**Validation report form for post-registration changes for  
CDM project activities  
(Version 03.0)**

<b>Title and UNFCCC reference number of the project activity</b>	Landfill Gas Recovery and Flaring Project in El Verde Landfill Leon UNFCCC ID: 3378
<b>Process track</b>	<input type="checkbox"/> Prior approval <input checked="" type="checkbox"/> Issuance <input type="checkbox"/> Renewal of crediting period
<b>Version number of the validation report</b>	Version 1.1
<b>Completion date of the validation report</b>	22/04/2020
<b>Type(s) of PRCs</b>	<input checked="" type="checkbox"/> Temporary deviations from the registered monitoring plan, applied methodologies, standardized baselines or other methodological regulatory documents <sup>1</sup> <input type="checkbox"/> Corrections <input type="checkbox"/> Changes to the start date of the crediting period <input type="checkbox"/> Inclusion of a monitoring plan <input type="checkbox"/> Permanent changes to the registered monitoring plan, or permanent deviation of monitoring from the applied methodologies, standardized baselines or other methodological regulatory documents <input type="checkbox"/> Changes to the project design <input type

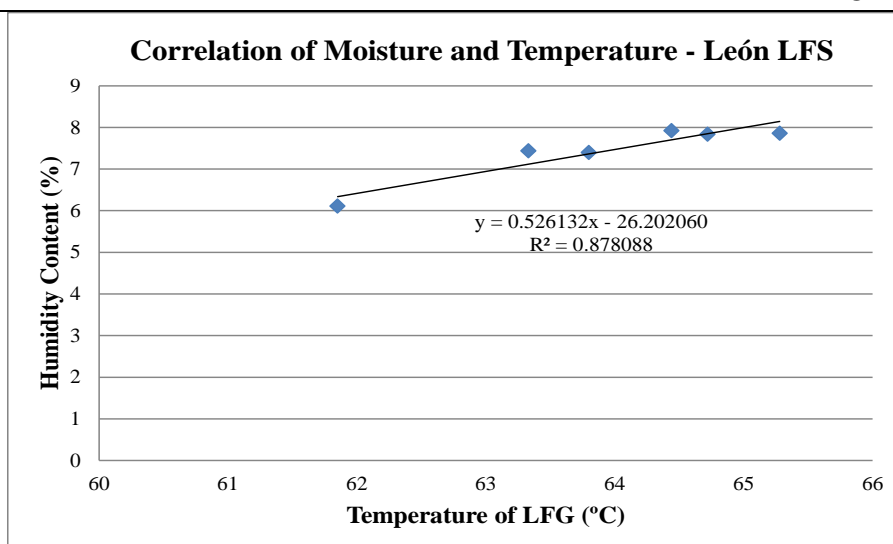
- 1) As per registered PDD, monitoring parameter "volumetric fraction of H<sub>2</sub>O in time interval t on a dry basis (vH<sub>2</sub>O,t,db)" is estimated using equation (8) of the "Tool to determine the mass flow of a greenhouse gas in a gaseous stream" version 3.0, for wet gaseous stream. Nonetheless the parameter has been determined in a different manner. Correction is requested.

- 1) During the first crediting period, the CDM-PDD did not have any reference to the "Tool to determine the mass flow of a greenhouse gas in a gaseous stream" to correct the flow to dry basis when the temperature was greater than 60°C and there was not guidance to properly apply it. Moreover, considering that during the monitoring period no separate monitoring of temperature and pressure is necessary since the PP is using flowmeters that automatically express LFG volumes in normalized cubic meters, there is no measurement of the pressure of the gas to apply the Option 2 (Simplified calculation without measurement of the moisture content) of the "Tool to determine the mass flow of a GHG in a gaseous stream" version 3.0. Considering such situation, for the first submission of this monitoring period, rather than using the using equation (8) of the "Tool to determine the mass flow of a greenhouse gas in a gaseous stream" version 3.0, the PP hired the third party consultancy IECASA to measure the moisture content of the gas (vH<sub>2</sub>O,t,db) as can be evidenced with the "Moisture Content Report\_Leon\_Feb-11". The experiment was conducted by artificially (i.e increasing the booster's suction) increasing the temperature of the gas above 60°C and measuring the moisture content of the gas to find a correlation between the temperature of the gas and its moisture content, as follows:

Temperature LFG (°C)	vH <sub>2</sub> O,t,db (%)
63.33	7.429
61.85	6.103
64.44	7.916
64.72	7.828
63.80	7.389
65.28	7.852

Using the above values, the correlation was plotted as follows:

In the first submission of the current monitoring period, the PP corrected the monitored values of the parameter "VLFG,sent\_flare,y,db" to dry basis for the cases when T exceeded the 60°C using the following correlation based on the data measured by IECASA in the "Moisture Content Report\_Leon\_Feb-11":
